A47 Wansford to Sutton Dualling

Scheme Number: TR010039

Appendix 13.2 – Drainage strategy report

ENVIRONMENTAL STATEMENT APPENDICES
Appendix 13.2 – Drainage Strategy Report

Sheet 1 and 2

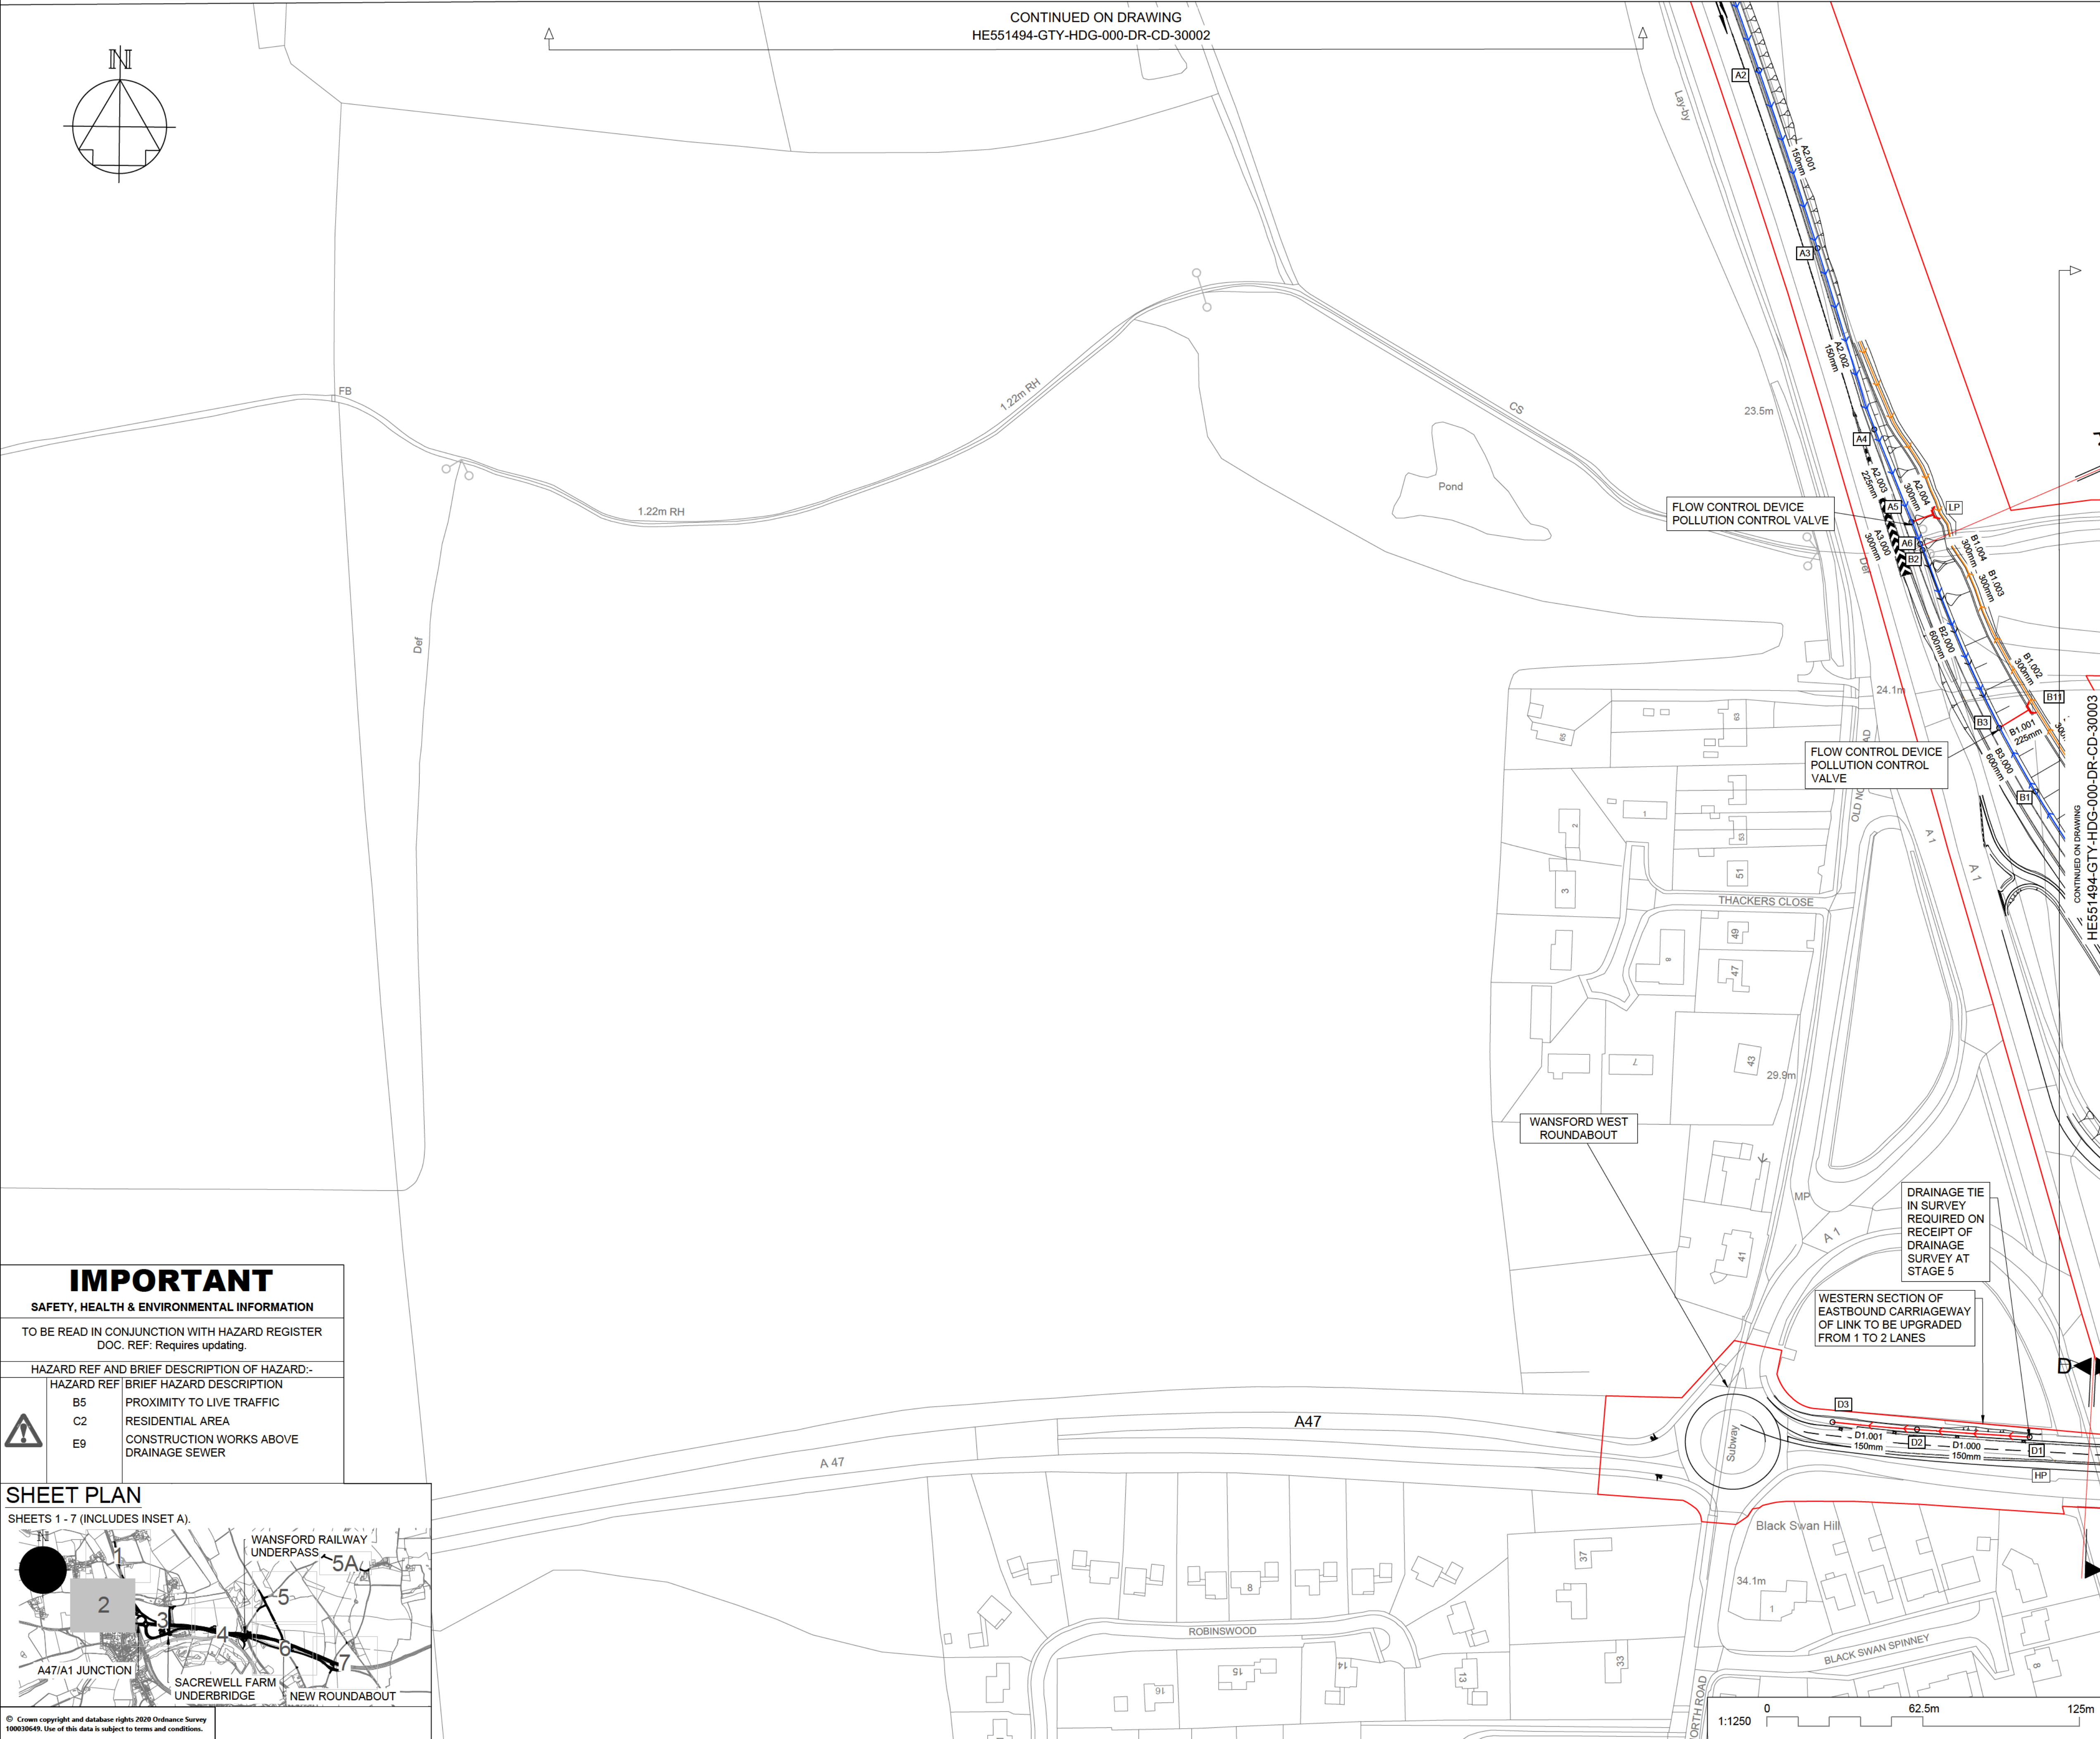
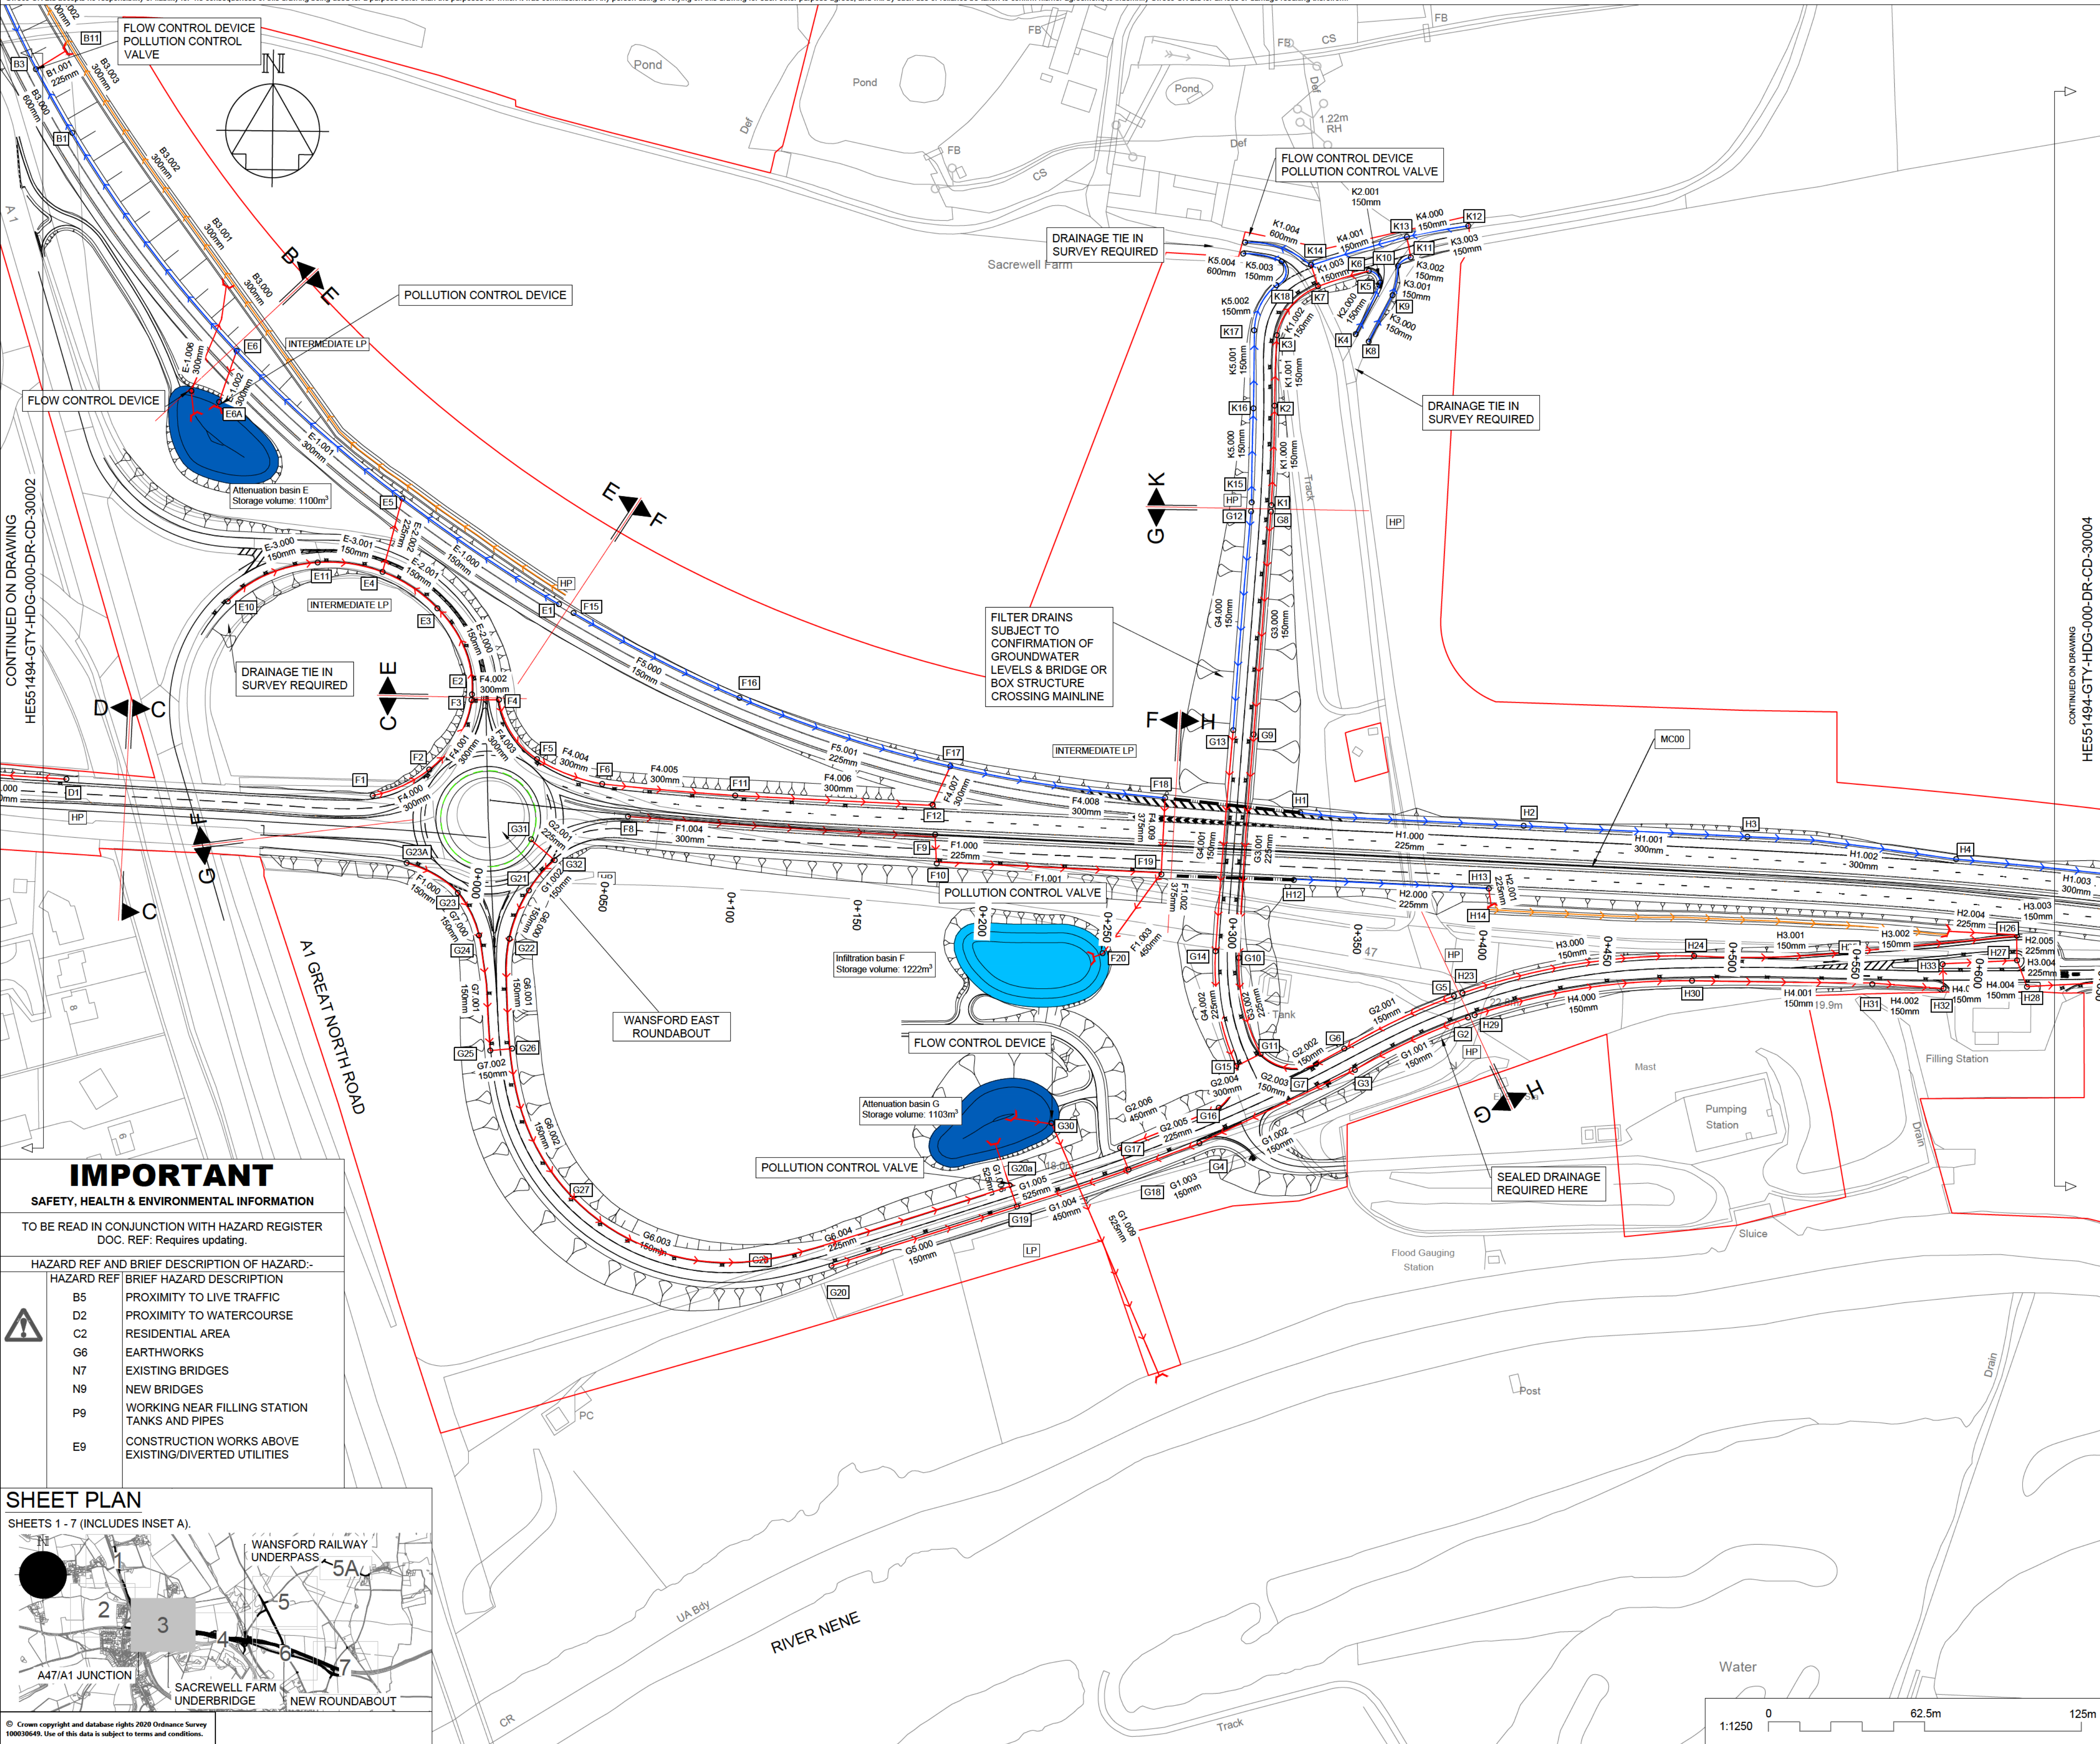
1. Network A is shown to be restricted by a flow control device, as such we need confirmation of how and where flows will be attenuated for up to the 1 in 100yr rainfall event + CC allowance and how much storage is required and provided as part of this system.
2. Network D - as we understand it there is an existing system on this junction and no changes are proposed to this section of road, if this is correct then the network (D1-D7) need to be eliminated from the drawing.

Sheet 3

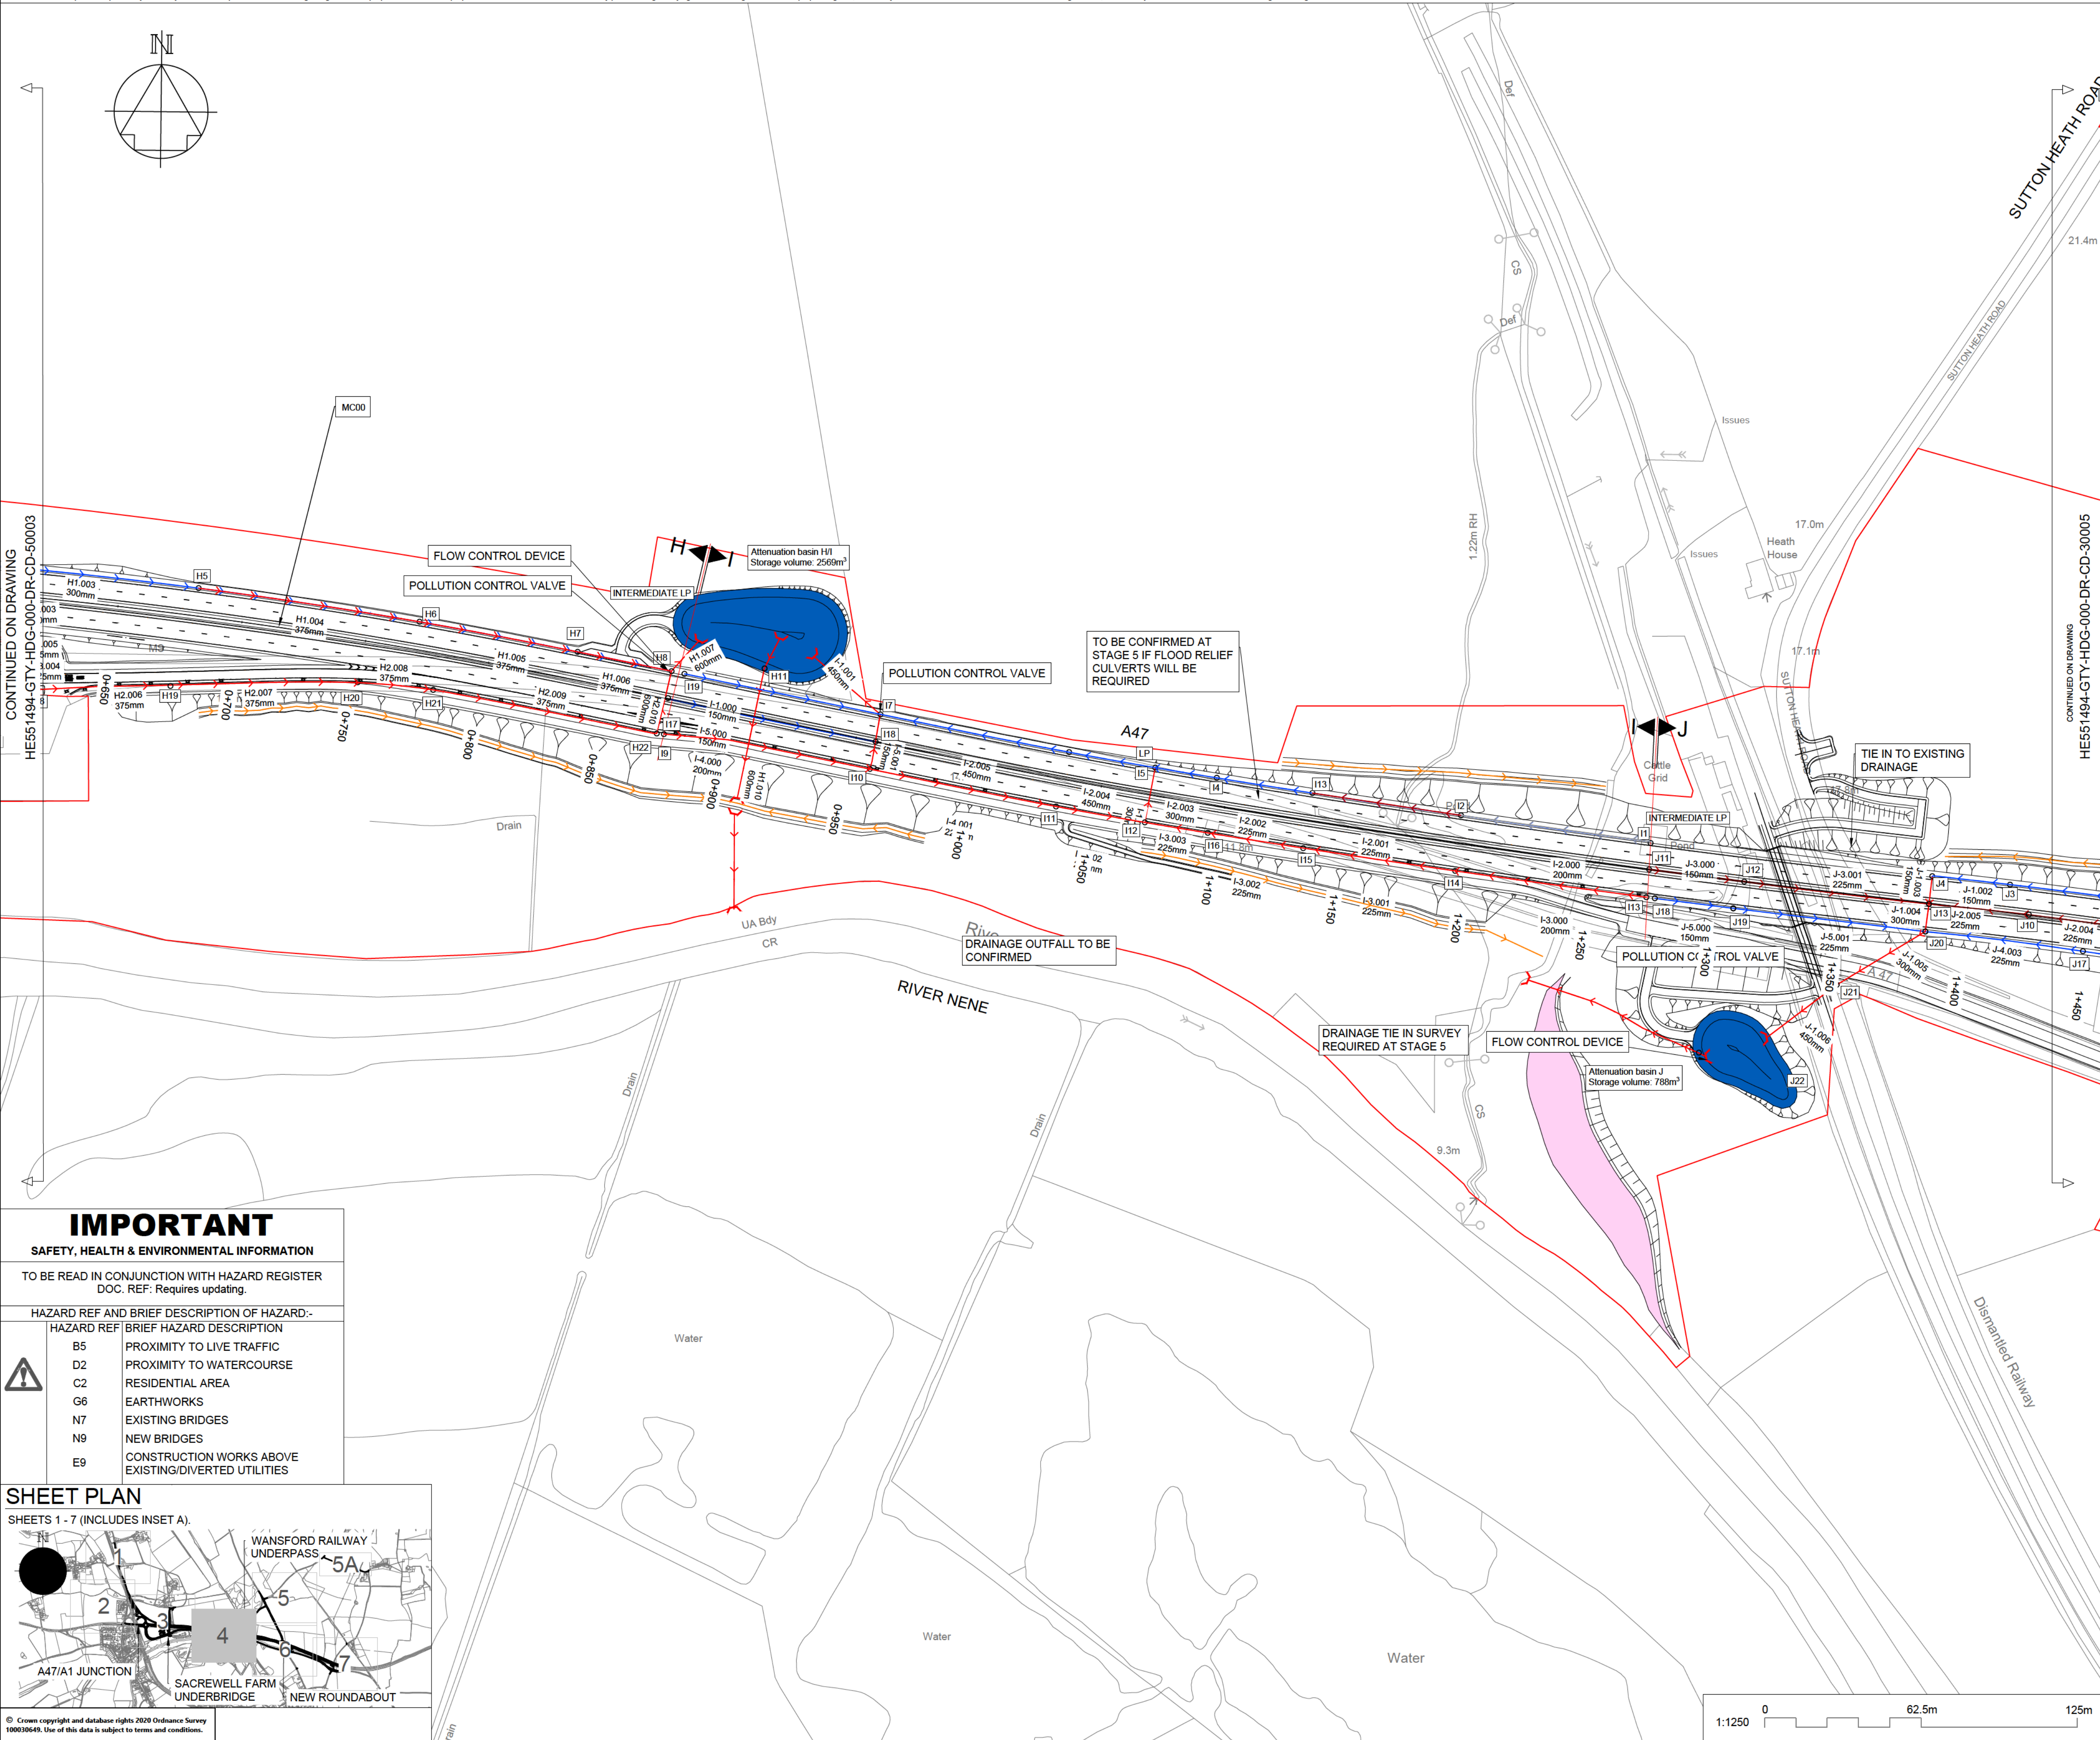
6. Network F - it appears from the drawing that the kerb drain system that serves the roundabout does not have a connection to the rest of network F. Should this be amended it would be logical to connect this to network G (F23 to G23 and F24 to G21).
